DOCKET ITEM #16
Development Special Use Permit #2019-00032
Special Use Permit (Restaurant) #2020-00033
Transportation Management Plan SUP #2020-00034
912-920 King Street

| Application | General Data | |
|---|-------------------------------|---|
| Project Name: 912 King Street | PC Hearing: | September 1, 2020 |

| Purpose of Application |
|--|
| Public hearing and consideration of a request for a development special use permit and site plan with modifications to construct 30-unit multifamily building with ground-floor commercial uses on the site of an existing City-owned parking lot. |

| Staff Recommendation: APPROVAL WITH CONDITIONS | |

Figure 2: Portion (in blue) of the new building that does not comply with the recommended 30-degree building envelope starting from King Street.

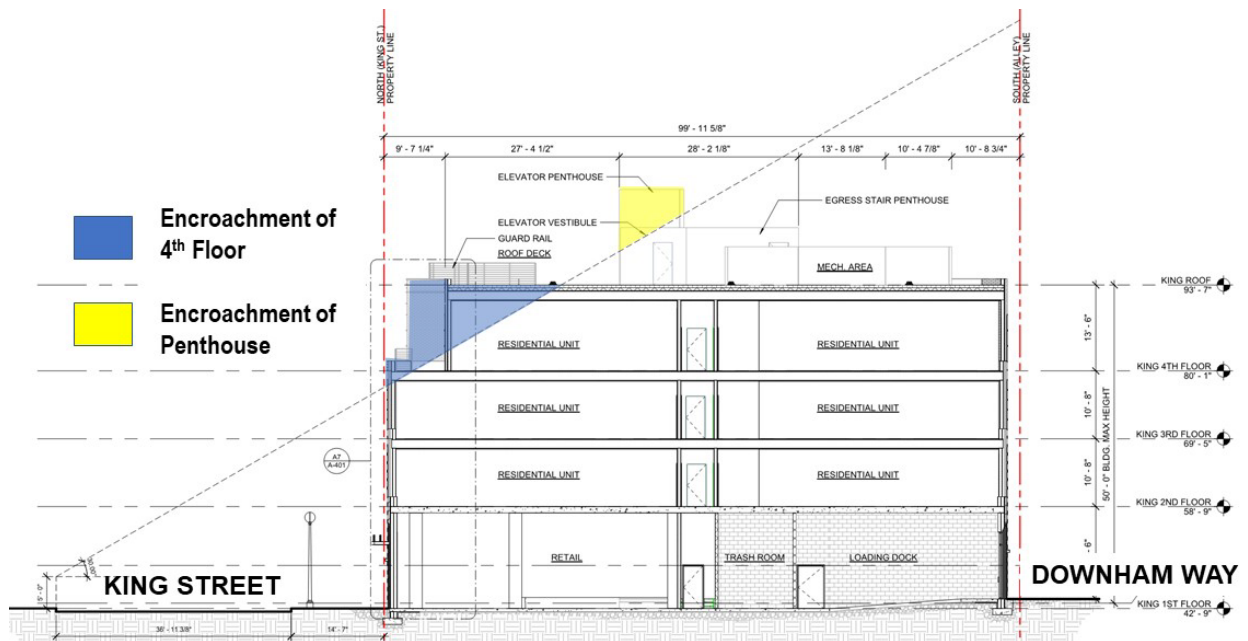
As shown in Figure 1 below, the proposed new building exceeds the building envelope at portions of the fourth floor and penthouse area in the areas of the building closest to King Street. This recommendation is not codified in the Zoning Ordinance, and there is no formal “modification” or “variation” to facilitate relief from a recommendation in the Strategy.

Staff supports relief from this recommendation as the building massing fronting King Street is “broken up” in a way that accentuates the height variations along the 900 block of King Street while complementing the existing character of the blockface, which also has a similarly tall façade at the adjacent Firehouse Square development. The western half of the building is set back 9 feet on the fourth floor in recognizing the spirit of the control plane recommendation, while the eastern half of the building has a strong 4-story expression at the building frontage, which is also present along portions of King Street. Additionally, the BAR discussed building height and the appearance of the building from King Street as part of the BAR concept review, and ultimately endorsed the building height and massing as proposed.
